Informal document **GRE-68-31**
(68th GRE, 16-18 October 2012,
agenda item 4(d))

Poland: comments on OICA comments on GRE/2012/27

**Headlamp Initial Aiming and leveling tolerances
influence for road illumination distance**

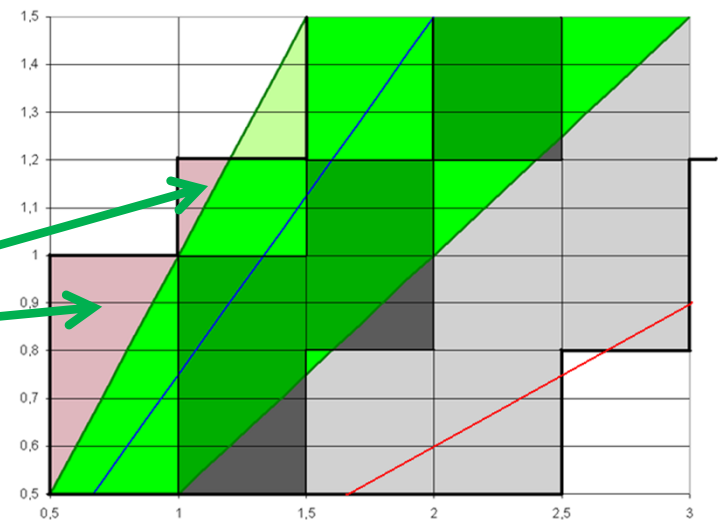
- Under proposal,
 - No overlap between height bands
 - Most headlamps would be aimed higher than at present

What for are needed overlaps?

- Risks increased glare.

It will depend on manufacturers decision and choice of range of amended Reg.48 (30 to 100m or 50 to 100m)

It will be safety oriented advantage and goal of amendment because of longer average road illumination distance.

Not true. Decreased glare comparing present state.

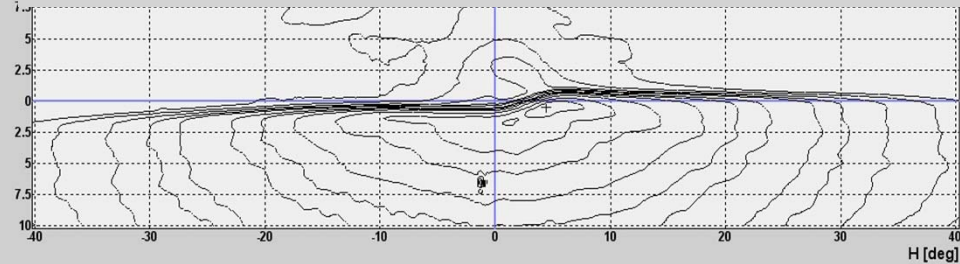
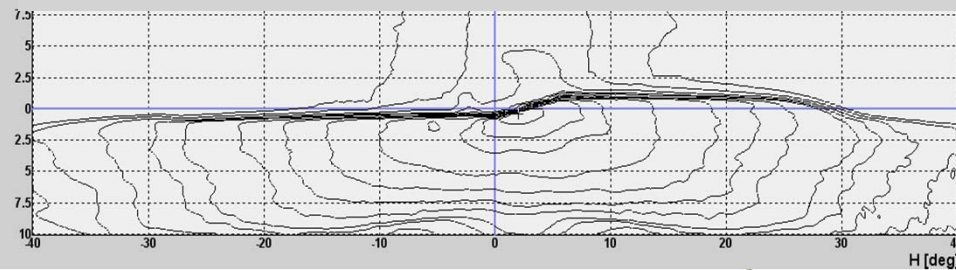
- Both lamps have a theoretical range of 75m
 - Sample 11 has TC4-45 visibility range of 60m
 - Sample 5 has TC4-45 visibility range of 85m
- **Conclusion: theoretical range is a poor measure of real-world visibility**

To objectively assess aiming/leveling results of GRE/2012/27 appropriate are calculations for **lowest allowed** leveling according present requirements **2.5% down aiming**. How big will be differences between both headlamps and where will be 3lx position on left side?

Have in mind **inverted square law**. **1% aiming is inappropriate** for this situation.

By **2.5% aiming** results should be very closed **to 28 m**

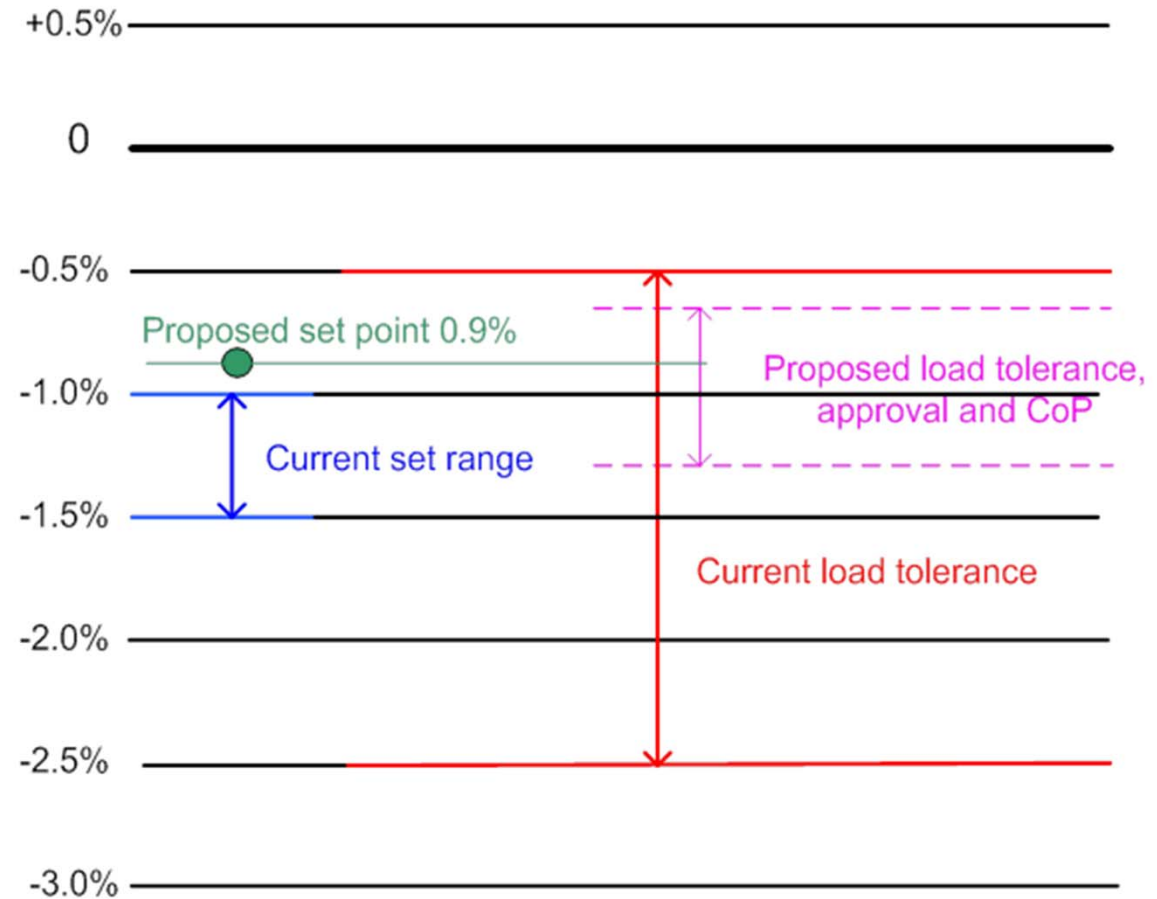
„The crossing distance could be lower but not less than [25 m or 30m] under the condition that there will be information for driver

It should be carefully verified. But... What is the problem?

Manufacturers convenience (because not technical possibility)

SAFETY OF MILIONS DRIVERS AND PEDESTRIANS

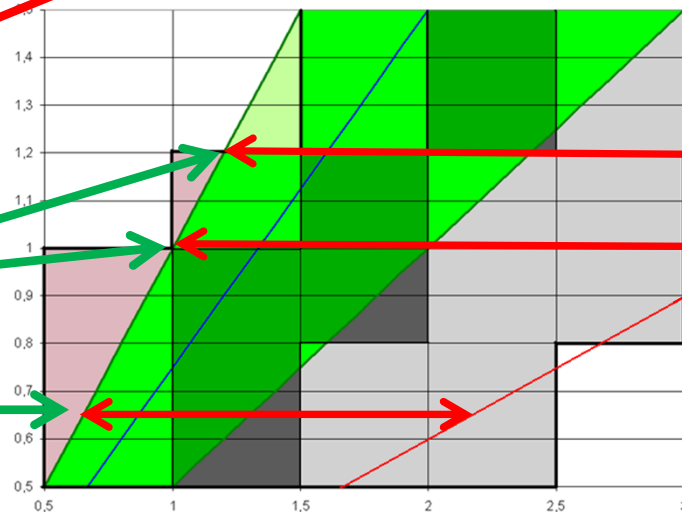
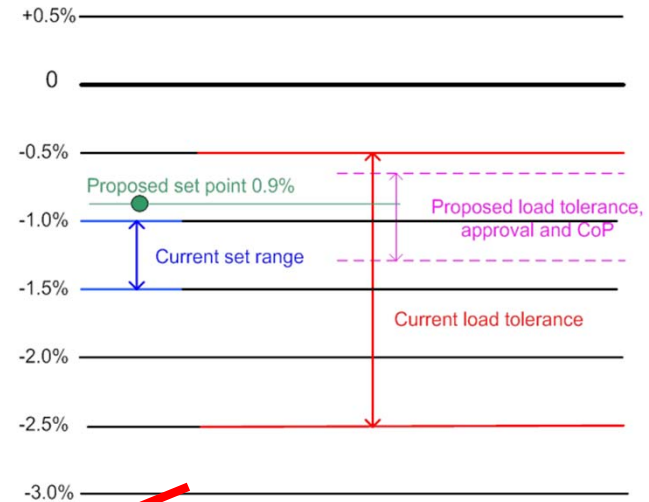
- To consistently meet CoP requirements, initial aim and levelling system need to be repeatable with a standard deviation of better than 0.1%.

Repeatability of suspension system alone is not this good.

Repeatability (tested in Motor Transport Institute including performance of suspension) for automatic leveling for many cars was much better than 0.1%

For same (van/SUV/delivery trucks) tolerances are bigger

For some cars (sport cars) are lower
